From: Daniel.J.Ridgeway@jci.com [mailto:Daniel.J.Ridgeway@jci.com]
Sent: Monday, June 18, 2012 11:14 AM
To: Smythe, Larry
Subject: Fw: GTR7 Email Sent By (smythel@nrd.nissan-usa.com).

I had some folks at Johnson Controls review this document with the following comments. I doubt this has reached you in time, but wanted you to at least get some feedback from our side.

Figure 1-3

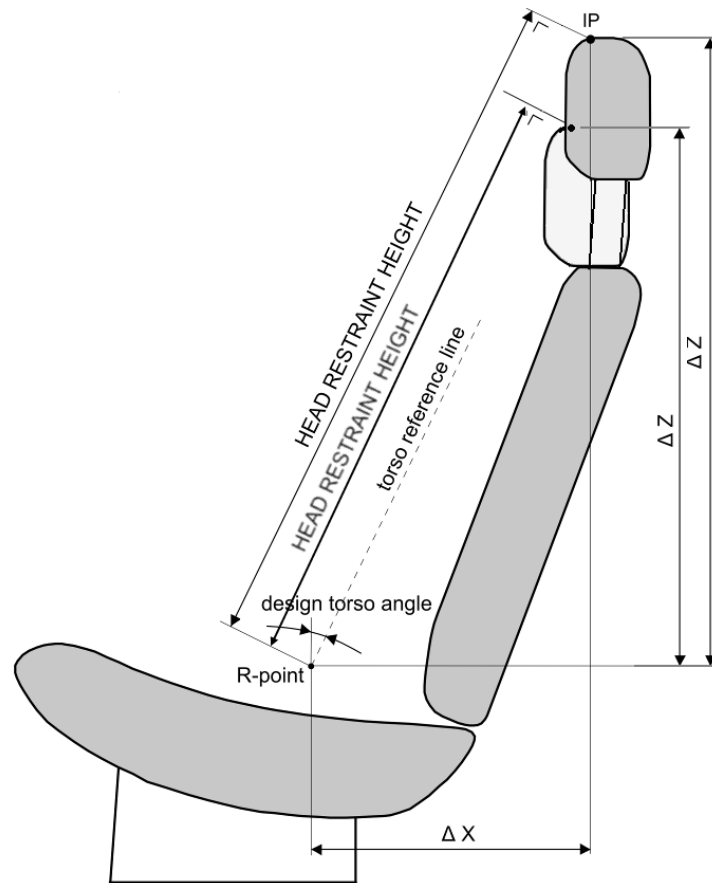
- The measurement in Annex 5 does not take into account HRs with a non vertical front surface. It only measures the point horizontal from the center of the HRMD. If the HR has a significant forward or rearward angle the physical backset measurement using the probe could be different.

- I didn't see anything in the document about 3D cad measurement in the document? I agree the measurements are not repeatable. It appears the method for determining the head restraint height is changed. You find the point on the head restraint along the horizontal then measure the horizontal touching point along the torso angle - may be a slight change in the head restraint height values according to the STO.
